**HISTORIC DISTRICT
REVIEW COMMISSION**

**HISTORIC DISTRICT REVIEW COMMISSION
Regular Meeting Agenda**

**February 19, 2019
5:30 p.m.
City Council Chambers**

EXHIBIT D

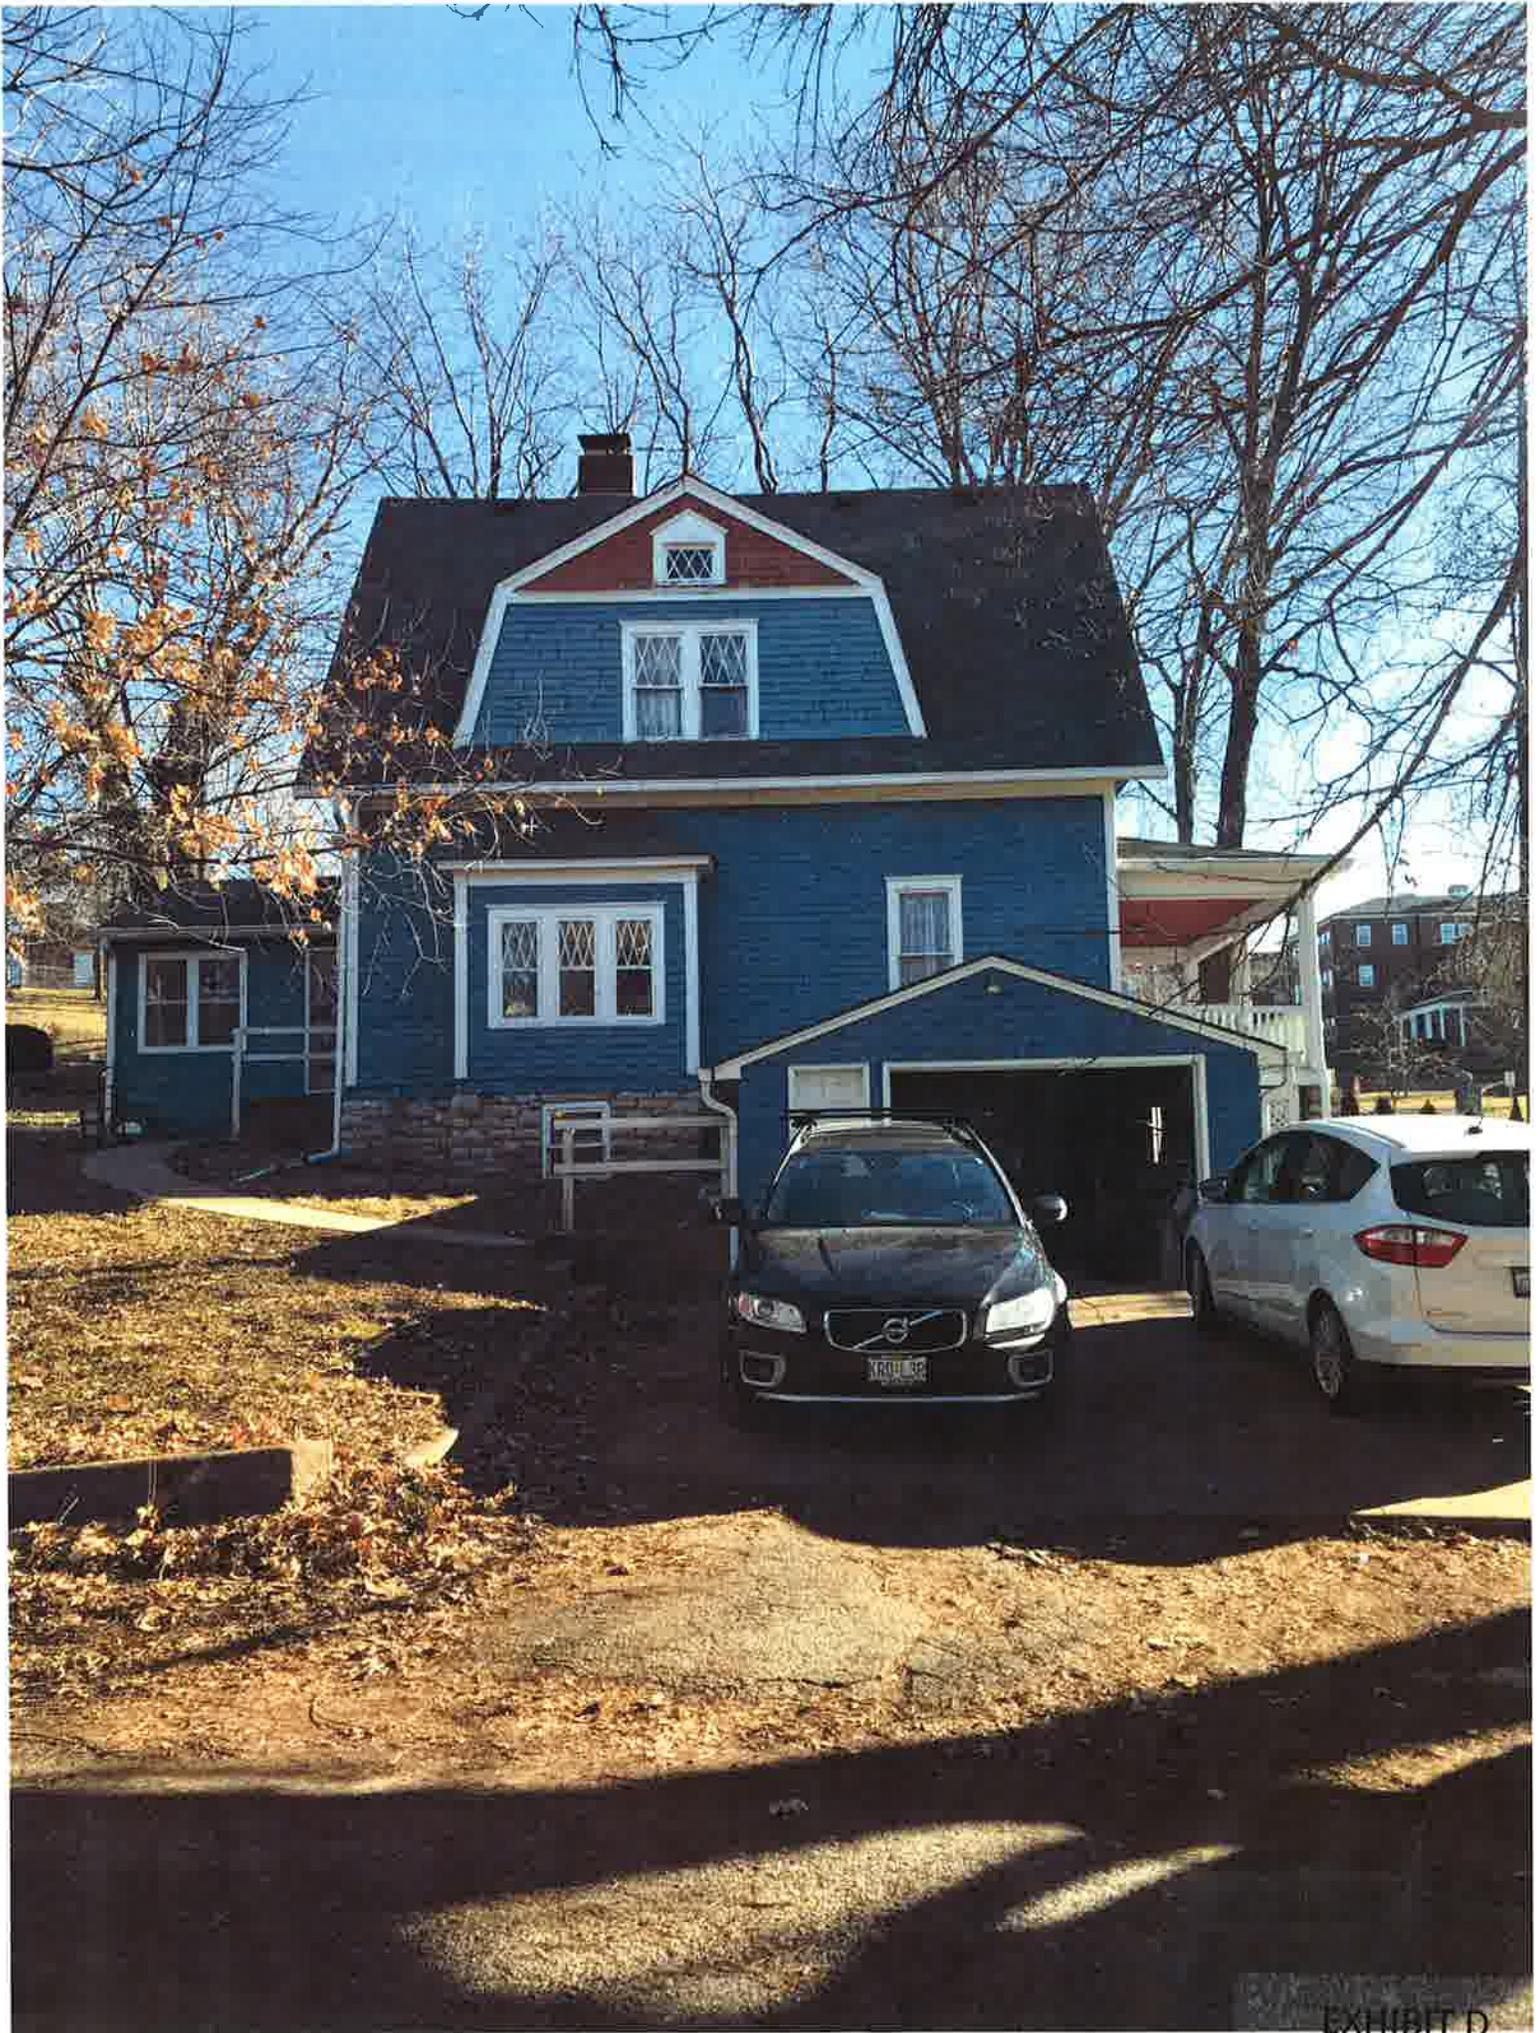
1. Replacing 4 matching twin double hung windows on north and west sides of home with Marvin Integrity Wood-Ultrex (fiberglass exterior, wood interior): twin double hung 60" x 53.5". The window size will not change.

2. Removing non-original doorway on the E side of the home and replacing it with awning window mentioned below.
3. Adding 2 windows to E side of home. Marvin Integrity Wood-Ultrex (fiberglass exterior, wood interior): 1x double hung 28" x 53.5", 1x awning 30" x 20"

4. Adding wood trim to replicate historic trim on the N/E/W elevations of the kitchen addition, which is on the N side of the home. Trim: 5" wide sashes, 4.5" top, with 2" molding cap detail on the top.

5. Adding a flush Velux sun tunnel (sky light) to the NE roof line, this will not be visible from the street.
6. Adding trim to N side of kitchen addition to match original trim. This will result in adding some rolled roofing to match existing, looks like: GAF Royal Sovereign charcoal.

The application meets the standards for review and the historic district design guidelines; therefore staff recommends approval of HDRC case #19-001J.
